5700 Surrey St. Hwy 35/6-07P
Somerset Historic District

HISTORIC PRESERVATION COMMISSION

SUBJECT: Historic Area Work Permit #471025 - Fencing installation

MONTGOMERY COUNTY HISTORIC PRESERVATION COMMISSION
STAFF REPORT

7

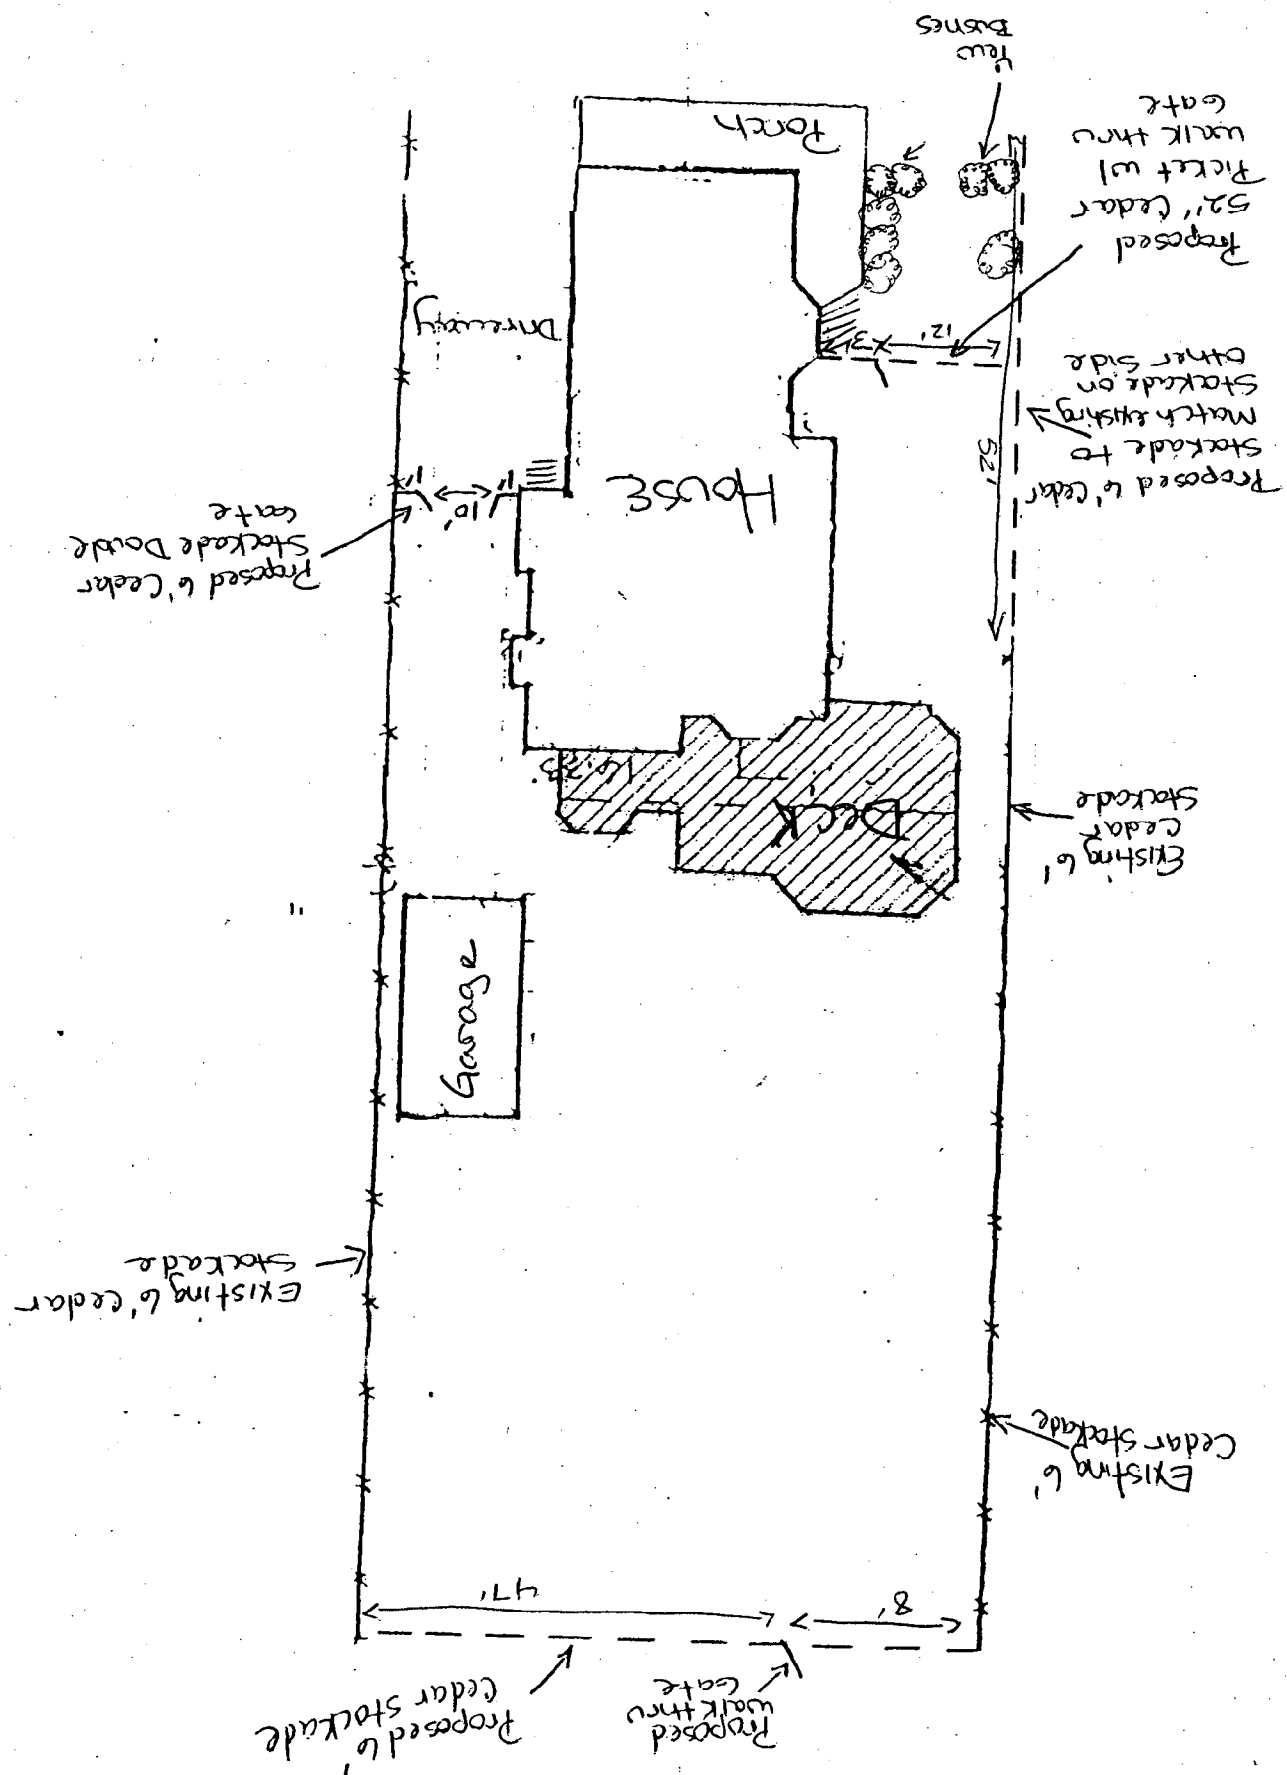
12 So staff had recommended, if you look in circle
13 seven, you can get a sense. They have existing stockade
14 fencing, and they are proposing some at the back. All of
15 that staff has supported. But then as you get up towards
16 the front of the house where it remains six feet tall, staff
17 has recommended that it be lowered. And also, on those
18 sections that cross from the side property lines to the
19 house, that those be lowered, and that on the left side, the
20 south side, that that be open. It is picket fencing, but
21 that it may not be taller than four feet.

8 And one possible solution would be, if you are
9 looking, again, at circle seven, where on the left side of
10 the house where that fencing comes in to meet the house at
11 that bay, maybe, perhaps, taller fencing could be allowed to
12 that point, and then it be lowered at that point; some sort
13 of compromise. They are concerned that the dog could jump
14 the fence if it's too low.

11 MR. MAZLISH: -- seven. The one thing that's odd
12 about seven that we drew slightly incorrectly, if you see
13 the stairs on the side of the porch, and it looks like the
14 fence goes past the stairs. And our intention is actually
15 for the fence to dead end into the stairs, and essentially
16 continue the -- if you look at the way that fence comes -- I
17 don't know what you call it, not a fence, but the railing
18 comes down, it comes down the same way on the back side, and
19 so to just continue that across.

3 MS. ALDERSON: Then it's recent. Okay, but the
4 fence is drawn on the left side. That is intersecting the
5 original house.

11 MS. FOTHERGILL: What he's referring to is the
12 forward extension that sort of mimics the one on the right
13 side on the left side, this piece here, he's saying they're
14 not wedded to that. And that is, in staff's looking at it,
15 one of the problematic pieces, because it's six feet tall,
16 you know, as you are coming up the block, visible, similar
17 to the one they have on the other side.

13 MS. ALDERSON: I concur, and I would not like the
14 fence at any height to be intersecting the side of the house
15 right in the middle of the bay. That's awkward. So it
16 needs to come, get pulled back further into the yard, back
17 yard.

6 MS. ALDERSON: What I was referring to is the bay.
7 It's very awkward having the fence return to the house in
8 the middle of the bay window.

16 MS. ALDERSON: We'd rather see it behind all that,
17 toward the back of the house. It's too far forward.

19 MS. ALDERSON: Yes. It shouldn't be, it shouldn't
20 be running into the historic block. So pull it back to the
21 rear.

1. The new fencing on the left (south) side will connect to the house behind the rear plane of the historic section of the house.
2. The new fencing forward of the rear plane of the historic section of the house on the left (south) side will not be taller than four feet.
3. The picket fencing adjacent to the left (south) side of the house will not be taller than four feet.
4. The fencing and gate across the driveway on the right (north) side will not be taller than four feet.

3 MS. ALDERSON: I think what we've settled on, and
4 I'm going to have to ask someone to correct me so that I'll
5 restate it if necessary. It's that we would approve the
6 application with the staff's conditions adding an additional
7 condition that the fencing should return to the house behind
8 the original house. And I think that covers it, doesn't it.
